Access Compliance Report

Public Rights-of-Way

(Curb Ramps)

Intersection ID: 31738	Main Street: LEAF_PLUM_DR	Cross Street: SAWLEAF_CT	Location: SE
ADA ID: EDF14E964C4F	Ramp Type: PerpDiag	Initial Pass/Fail: Pass	Overall Compliance: No
Severity Score: 5.25			
Codes/Mitigation Info/Possible Solution		Field Measurements/Component Compliance

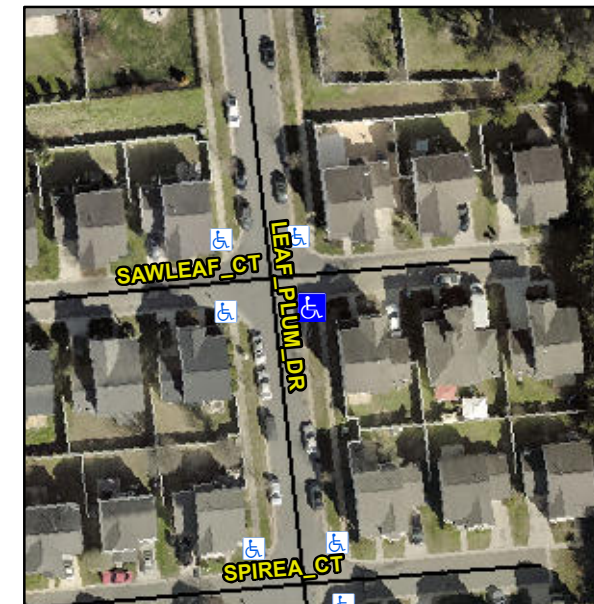
R304.5.3, R304.2.1, R304.2.2-Perp, R304.3.2-Para, R304.5.4

Compliance	Description	Data	Compliance	Description	Data
N/A	Ramp Length (in)	55.0	Yes	Ramp Slope (%)	6.3
Yes	Ramp Width (in)	48.0	No	Ramp XSlope (%)	2.9
N/A	Flare Type LT	Sloped	N/A	Flare Type RT	N/A
N/A	Flare Slope LT (%)	12.1	N/A	Flare Slope RT (%)	2.0
N/A	Flare Traversable LT?	No	N/A	Flare Traversable RT?	No
No	Landing Length (in)	32.0	Yes	DWS Provided?	Yes
Yes	Landing Width (in)	48.0	Yes	DWS Contrast?	Yes
No	Landing Slope (%)	3.2	Yes	DWS Length (in)	24.5
No	Landing X Slope (%)	4.3	Yes	DWS Full Width?	Yes
N/A	Landing Curb? (Y/N)	No	Yes	DWS Offset (in)	2.0
N/A	Shared Landing?	Yes			
Yes	Gutter Ponding?	No	No	Gutter Slope (%)	9.2
Yes	Gutter Lip Ht (in)	0.0	No	Gutter X Slope (%)	3.3
N/A	Painted X Walk1?	No	N/A	Painted X Walk2?	No
	X Walk 1 Direction	To N		X Walk 2 Direction	To W
N/A	X Walk 1 Width (in)	N/A	N/A	X Walk 2 Width (in)	N/A
	X Walk 1 Slope (%)	3.9		X Walk 2 Slope (%)	0.2
	X Walk 1 X Slope (%)	3.3		X Walk 2 X Slope (%)	2.2

Remove & Replace Curb Ramp With Two New Directional Ramps or Equivalent. Remove & Replace Gutter.
